28F008S3

SPECIFICATION UPDATE

Release Date: February 1997

Order Number 297799-003

Successive Read Operations That Have Long CE#-High Pulse Widths

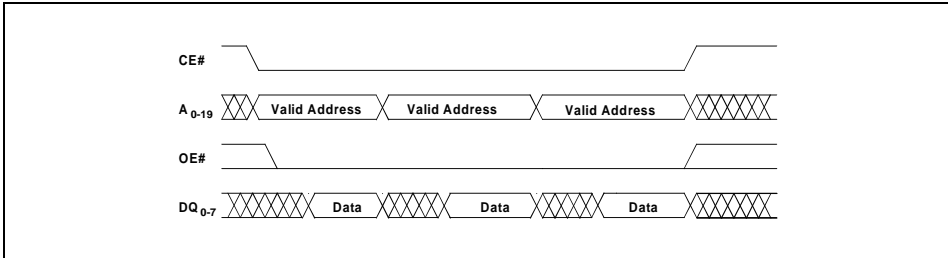
PROBLEM: The component may return invalid data if more than fifteen successive read operations are performed where CE# is deasserted between each read and the corresponding CE#-high pulse width resides within the specifications outlined in the table below.

Stepping	CE#-High Pulse Width (t_{EHEL})	
	Min	Max
A-1 and -3	100 ns	40 μ s
A-6	240 ns	700 ns

Access the Flash with CE# Active

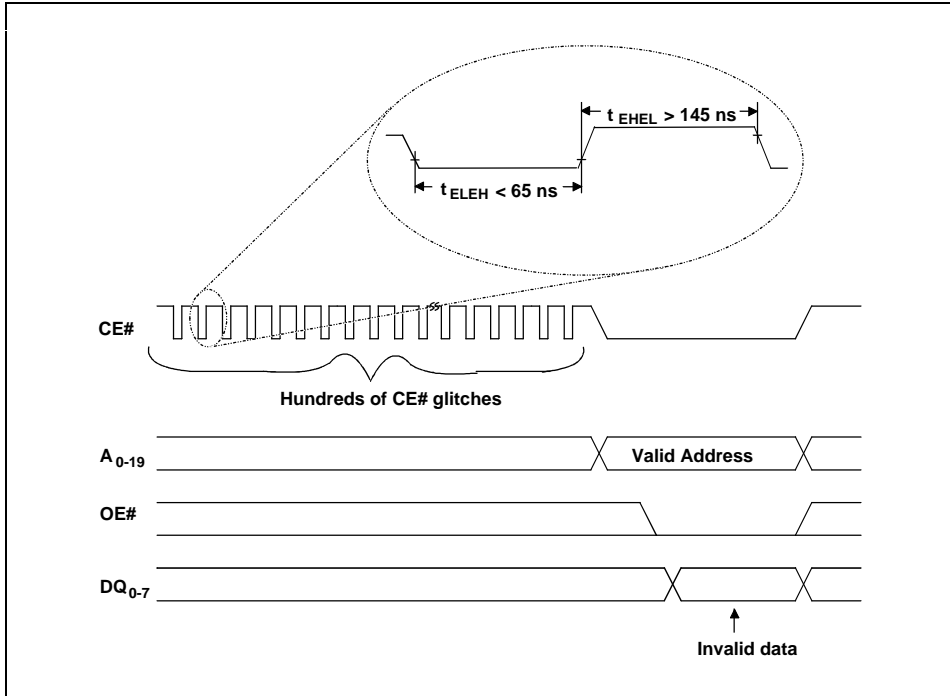
If it is determined that CE#-high time violations occur, carefully examine subsequent reads. If the ratio of good to bad (CE#-high times within the specifications outlined in the table above) reads is high, your system may not have a problem. For every bad read the system performs, five good reads for A-1 and A-3 stepping and two good reads for A-6 stepping are needed to cancel the effect of the bad read. So, carefully analyze the flash memory CE# input to understand the CE#-high characteristic.

1. Read more than four good reads for A-1 and A-3 stepping and only one read for A-6 stepping during each assertion of CE#, as illustrated in the figure above.
2. Issue a Byte Write command and program FFh to any location before executing a read operation. Programming FFh will not alter stored data, but it will give the component sufficient time to prepare for the read operation.
